RCOD #23-03 (79 Parkway Plaza)

11-21-2024 Notes for Applicant (DGL updated comments 12/5/24 & 02/20/25)

PARKWAY PLAZA PROJECT

SD-1

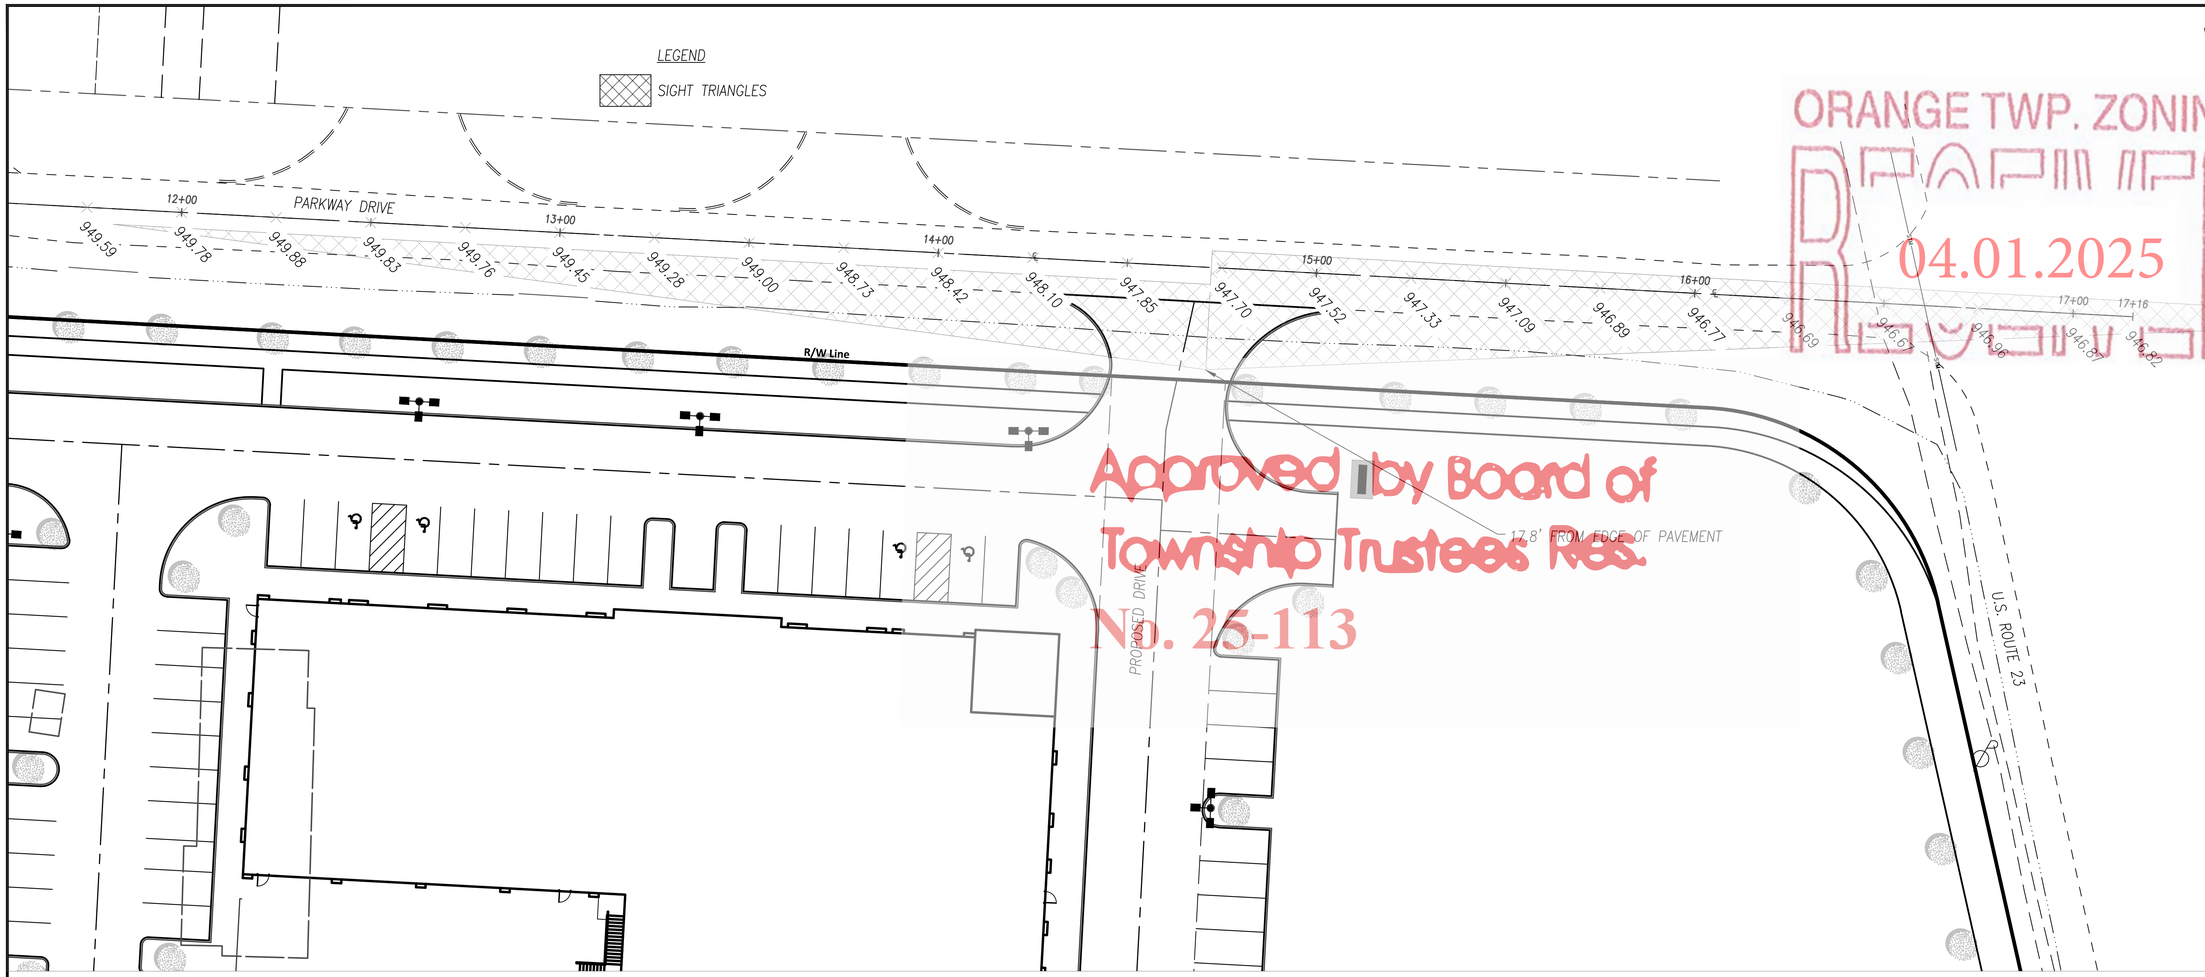
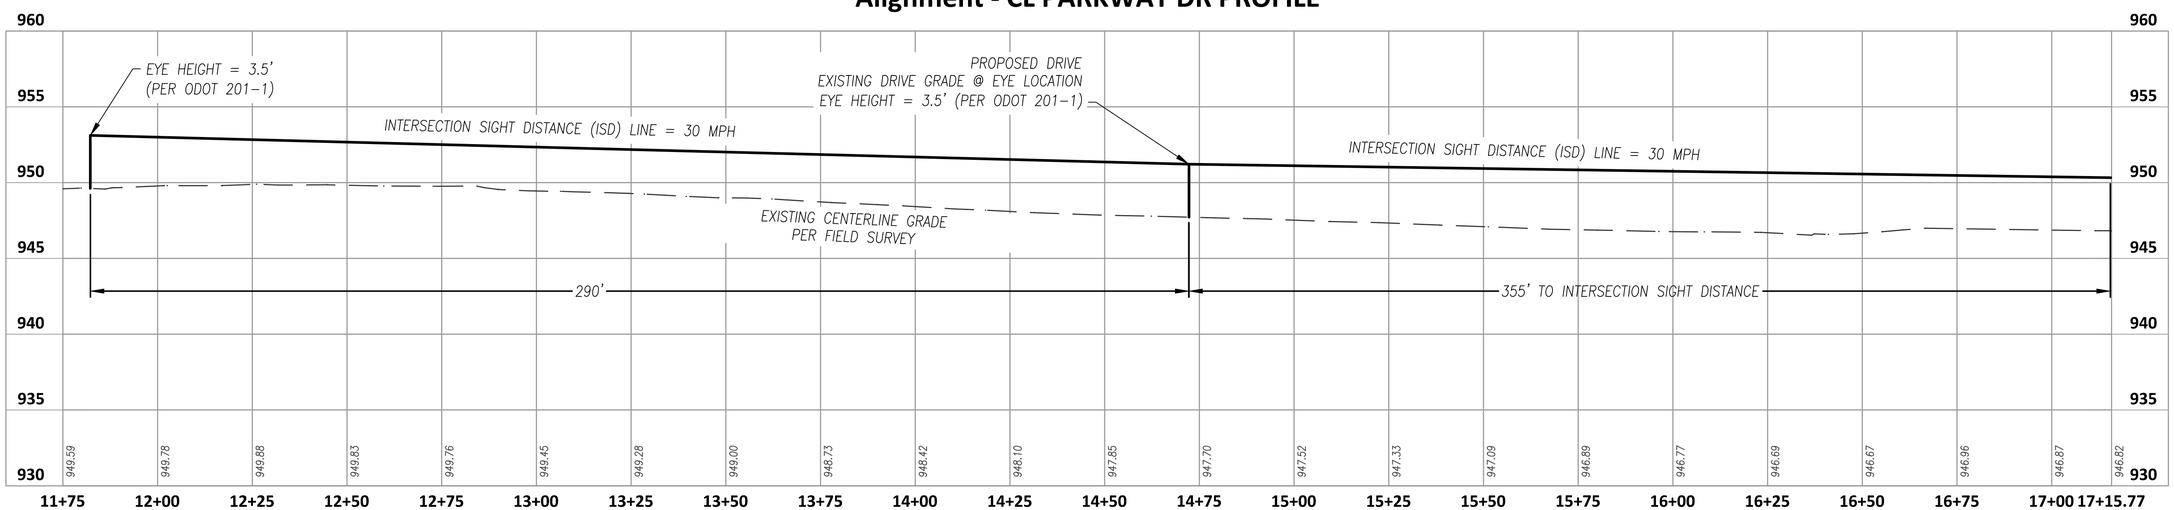
- Updated utility letters, along with the confirmation of sight distance from the County Engineer's office, should be submitted. – **Updated Letter are attached and please ref. to SD-1 for sight line**

C-1.0

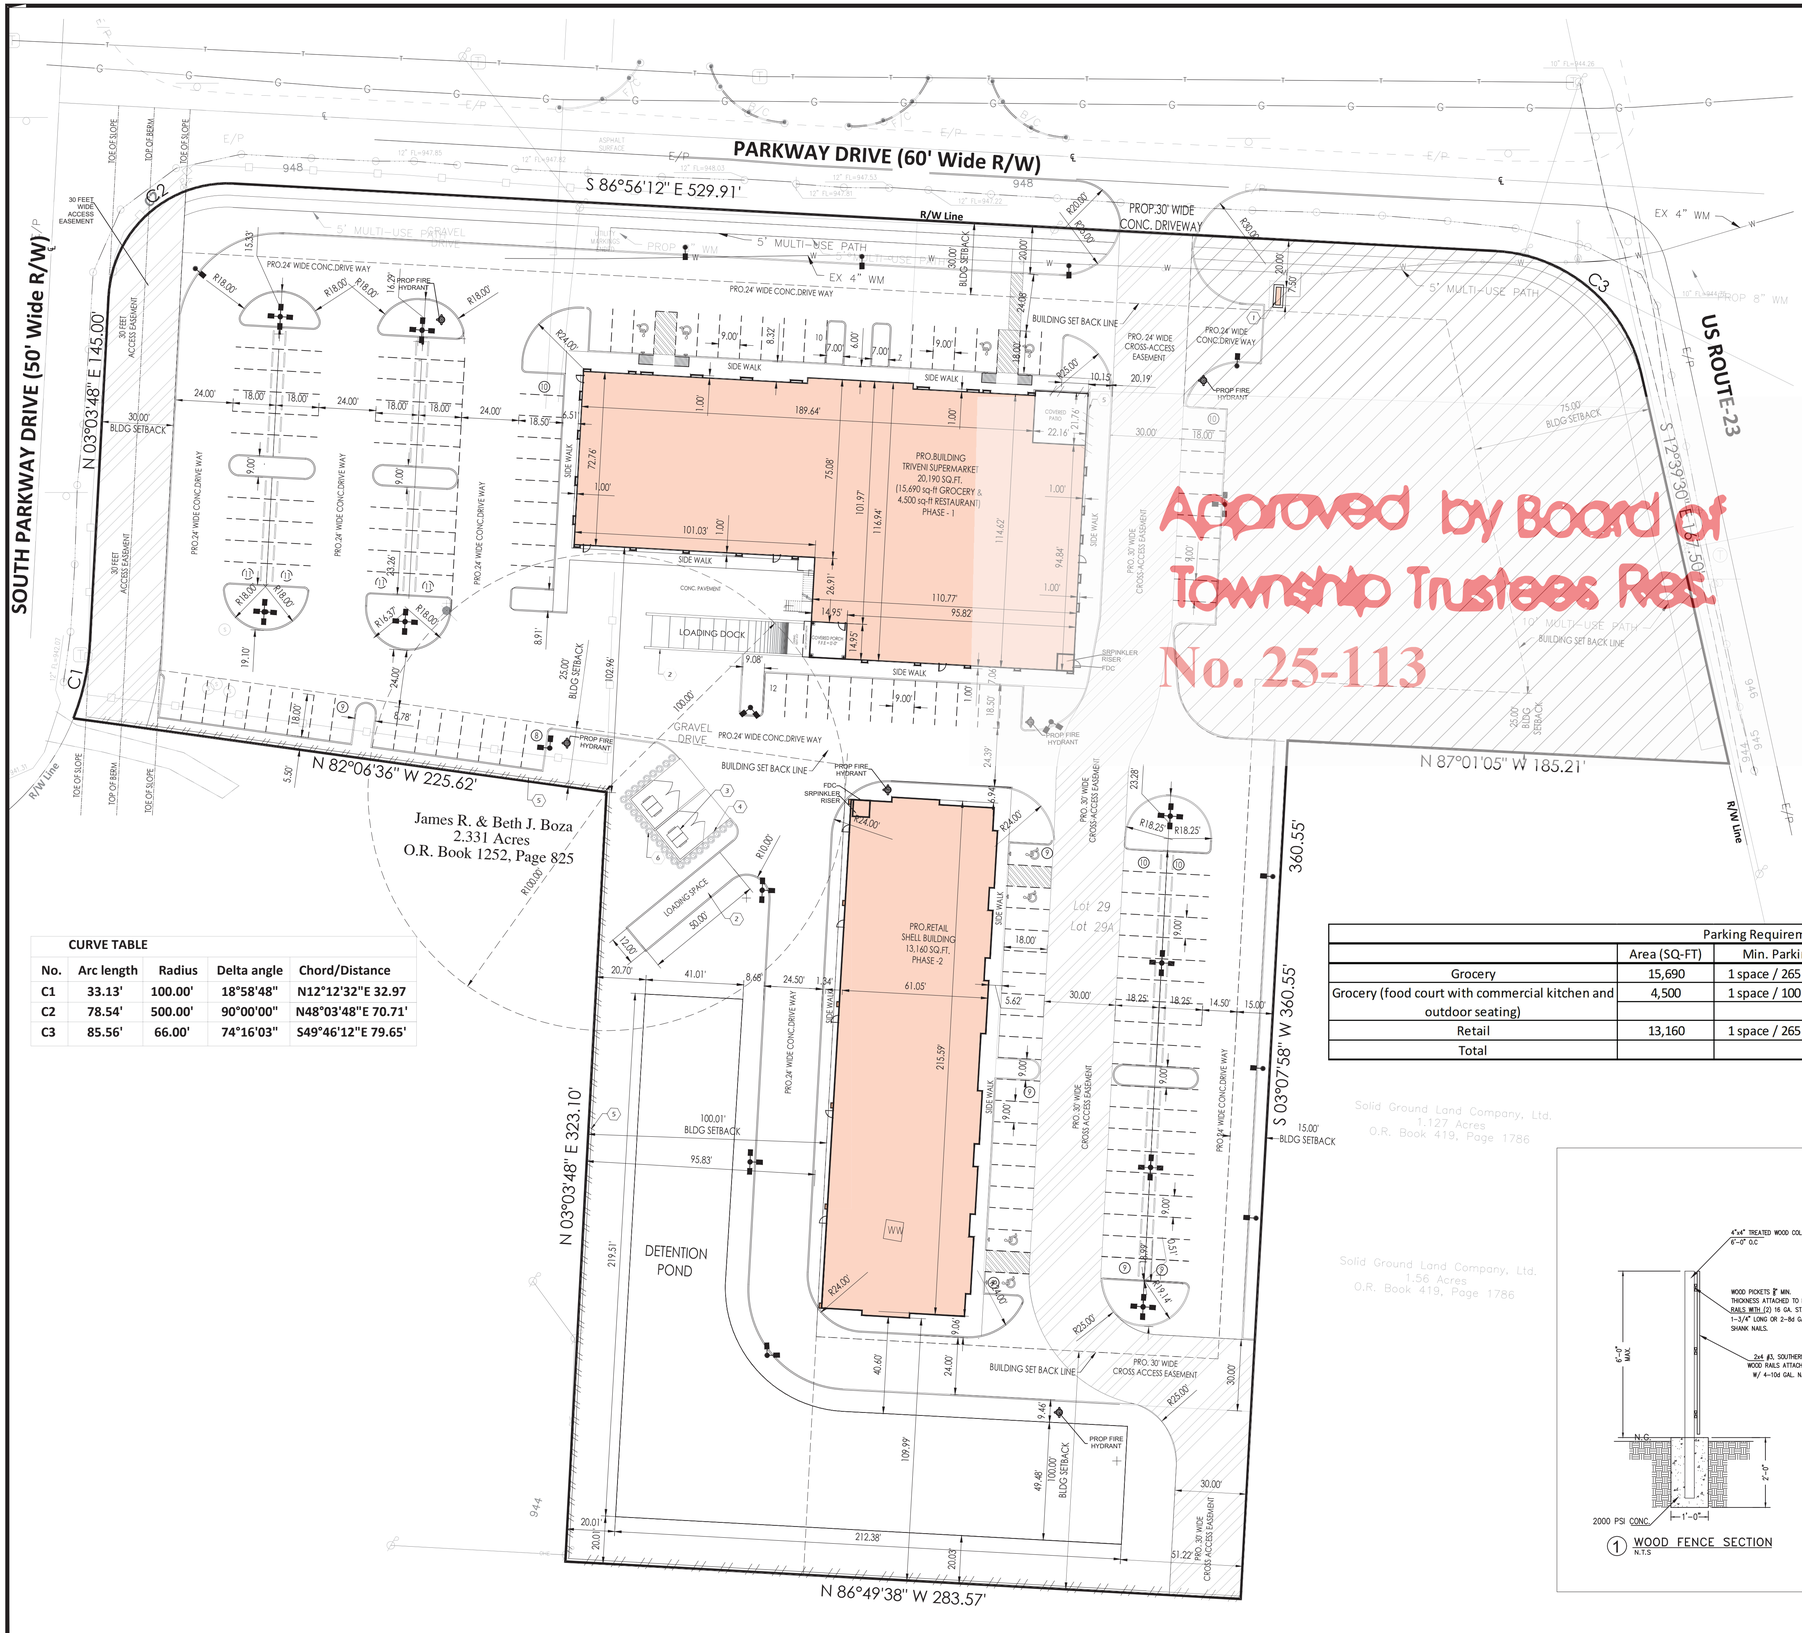
- Remove the 16 parking spots along the northwest side of the development, along S Parkway **DGL removed**
- Confirm the location and detail of the privacy fence (current application shows a wrought iron style fence, which does not provide privacy**)** **DGL added privacy note to the current fence call-out. Should more fence be shown?** Architect – Wooden fence detail has been added. Please refer to sheet C-1.0

SHEET NUMBER:
C-1.2

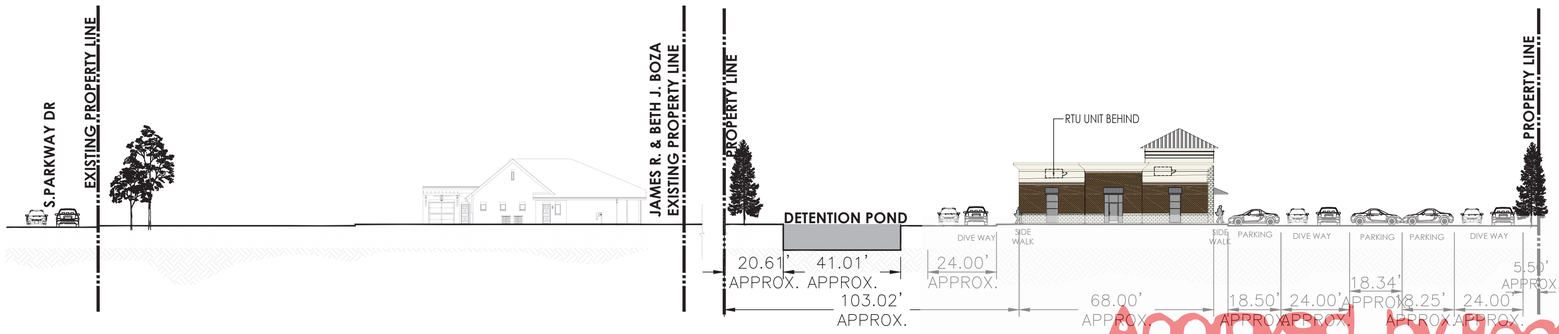
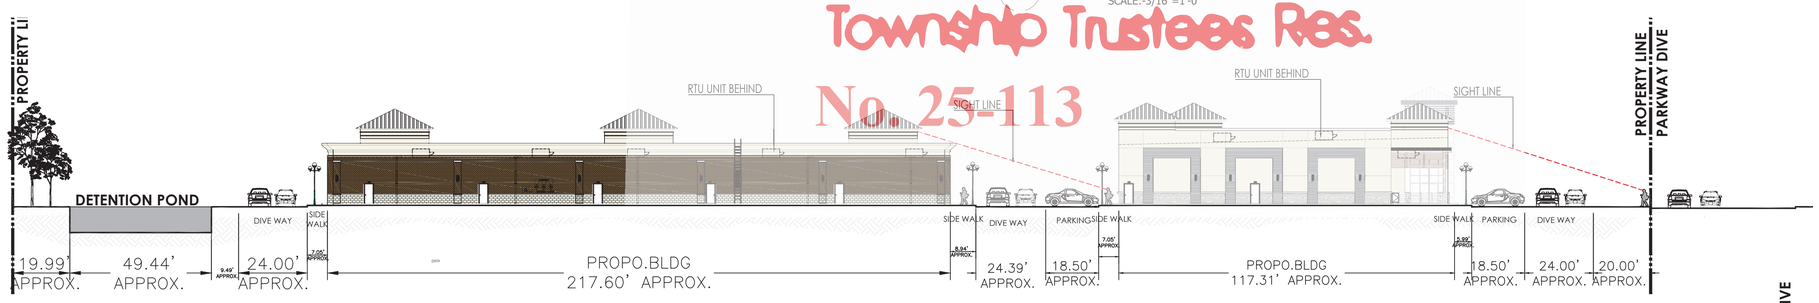
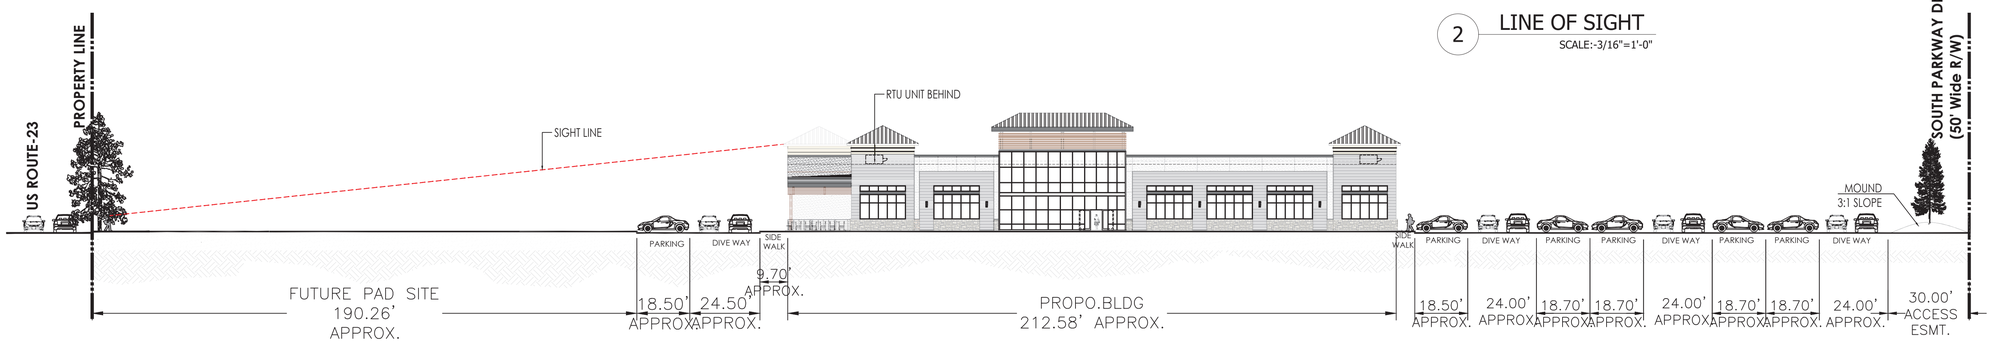
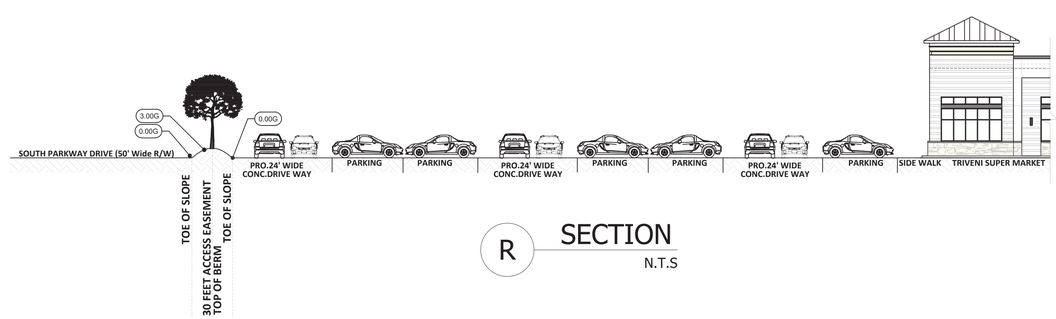
- Confirm the drive width in C1.2 and throughout the application (in some places the application shows 24-foot width or 30-foot width) **DGL labeled the drive widths**
- Confirm that the information in the lighting plan matches the landscape plan, yes
- Provide a lighting plan that extends 30 feet onto neighboring property. I did notice that the footcandle levels on the residential property to the SW are higher than what is allowed (0.3 is the max per code) in the area behind the dumpsters. That nearby light pole may need to be moved, or a divergence requested for this discrepancy. – Ref. Photometric plan
- Provide a copy of the letter from the Engineer's office stating that access and sight distance is adequate **DGL provided exhibit and County responded with no issues by email**.
